# UNITED STATES PATENT AND TRADEMARK OFFICE

<b>Office Action Summary</b>	Application No. 10/698,751	Applicant(s) SCHMITZ, ROGER W.	
	Examiner Jason M. Han	Art Unit 2875

## **DETAILED ACTION**

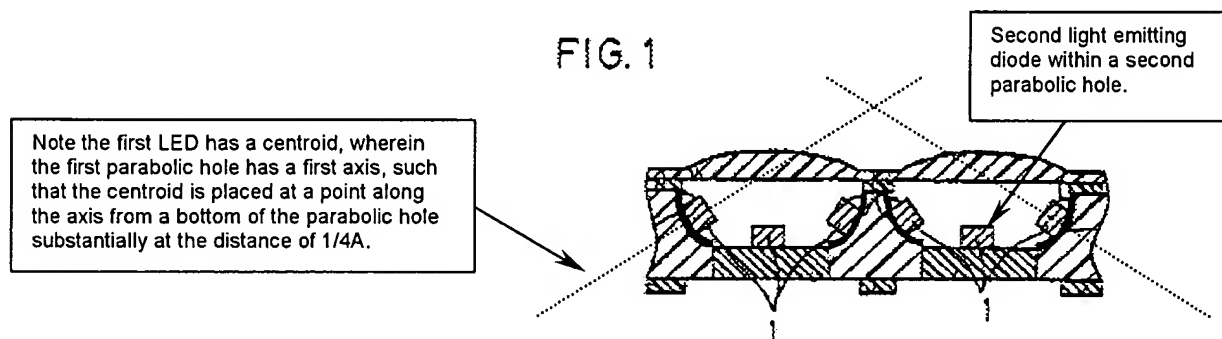
6. Claims 9-15 and 38 are rejected under 35 U.S.C. 102(b) as being anticipated by Kamada et al. (U.S. Publication 2002/0006040).

7. With regards to Claim 9, Kamada discloses a lighting structure including:

- A reflector [Figure 1: (10, 11a); Page 2, Paragraph 51] having a first concave hole formed [Figure 1: (11)] therein;
- A first light source [Figure 1: (1)] in the first concave hole; and

- A first filter [Page 8; Paragraph 115, "an optimum filter (not shown) may be provided on the surface of the LED chips 1 for adjusting the emission luminance")] positioned so that at least a portion of the light from the first light source passes therethrough.
8. With regards to Claim 10, Kamada discloses the first light source being a first light emitting diode [Page 1, Paragraph 46].
9. With regards to Claim 11, Kamada discloses the first concave hole being a first parabolic hole shaped at least in part as a parabola [Figure 1: (11a)].
10. With regards to Claim 12, Kamada discloses the first light emitting diode having a centroid and wherein the first parabolic hole has a first axis and a shape substantially in the form of  $y = Ax^2$ , the centroid being placed at a point along the axis from a bottom of the parabolic hole substantially at the distance of  $1/4A$ .

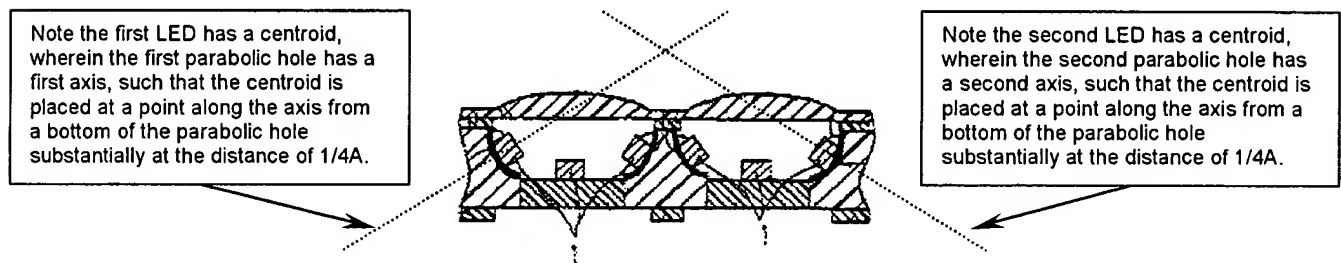
11. With regards to Claim 13, Kamada discloses a second parabolic hole [Figure 1: (11); note above drawing] formed in the reflector [Figure 1: (10, 11a); Page 2, Paragraph 51]; a second light emitting diode [Figure 1: (1); note drawing above] in the second parabolic hole; and a second filter [Page 8; Paragraph 115, "an optimum filter (not shown) may be provided on the surface of the LED chips 1 for adjusting the

emission luminance"] positioned so that at least a portion of the light from the second light emitting diode passes therethrough.

12. With regards to Claim 14, Kamada discloses the first and second light emitting diodes each having a centroid and wherein the first and second parabolic holes have a first and second axis respectively, and a shape substantially in the form of  $y = Ax^2$ , each centroid being placed at a point along the first and second axis from a bottom of the first and second parabolic holes substantially at the distance of  $1/4A$ .

13. With regards to Claim 15, Kamada discloses the first and second axes substantially intersecting [note drawing above].
